GENERAL INFORMATION

Applicant:	Walser Real Estate, LLC (Owner) Walser Toyota (User)
Location:	4401 American Boulevard West
Request:	1) Rezone a portion of 4401 American Boulevard West from CS-0.5(PD) to C-1(PD) for the expansion of a motor vehicle sales facility (Class I and II) 2) Major Revision to Preliminary Development Plans and Final Development Plans to construct a new three-story parking ramp with roof parking
Existing Land Use and Zoning:	Class I and II motor vehicle sales facility; zoned Commercial Service (Planned Development) and Single-Family Residential, CS-0.5(PD) and R-1
Surrounding Land Use and Zoning:	North – Interstate 494; public right-of-way South – Single-family residential dwellings; zoned R-1 East – Restaurant; zoned CS-0.5(PD) West – Office and multiple-family residential apartments; zoned CS-0.5 and R-4(PD)
Comprehensive Plan Designation:	Regional Commercial (RC)

PROPOSAL

Case PL2020-55

Figure 1: Rezoning from CS-0.5(PD) to C-1(PD)

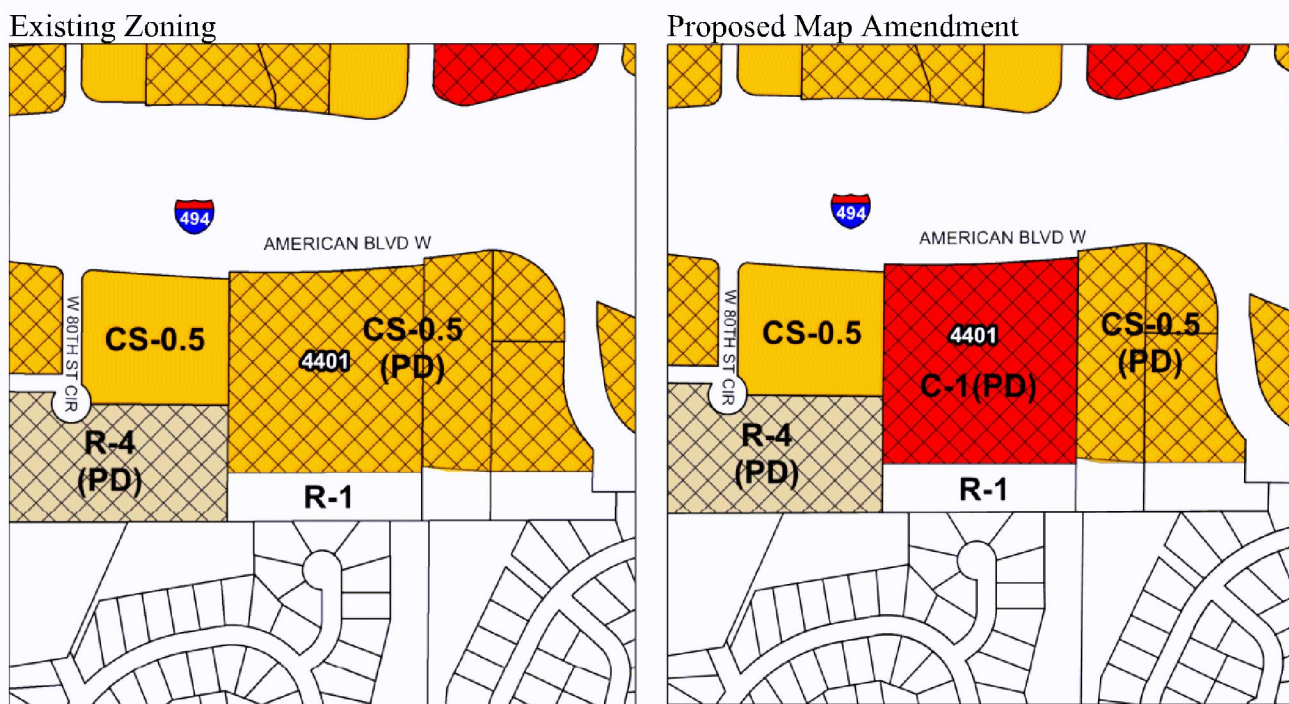
The subject property existing base zoning is split between CS-0.5 and R-1. The northern 80 percent of the site is zoned CS-0.5(PD), while the southern 20 percent (150 feet from the southern property line) is zoned R-1. The applicant requests rezoning the northern 80 percent of the site from CS-0.5(PD) to C-1(PD), as shown in Figure 1. In the CS-0.5 zoning district, a Class I motor vehicle sales facility is a conditional use, whereas it is a permitted use in the C-1 zoning district. The C-1 zoning district is intended to provide for a variety of non-retail uses that benefit from exposure and/or proximity to freeway corridors and interchanges, including Class I and II motor vehicle sales. There are currently only three other sites in the city zoned C-1, all of which are Class I and II motor vehicle sales facilities. A motor vehicle sales facility is a conditional use in the CS-0.5 zoning district, previously requiring the approval of Conditional Use Permits as the current facility was developed and expanded through the years. Rezoning the site to the C-1 zoning district would remove the requirement for a Conditional Use Permit, as motor vehicle sales uses are permitted in the C-1 district.

From a public benefit standpoint, rezoning a property with a major Class I and II motor vehicle sales use to the C-1 zoning district is in greater conformance to the intended vision and application of the Zoning Code. The C-1 zoning district provisions would not allow for the motor vehicle sales facility to be reduced in floor area for the purposes of maximizing the storage of automobile inventory. The C-1 zoning district was intended to be utilized for Class I and II motor vehicle sales uses, so it remains a more appropriate base zoning for the subject property. Rezoning the property from the CS-0.5 zoning district to the C-1 district also removes the need for a Conditional Use Permit for the subject property. Staff is supportive of the requested rezoning action.
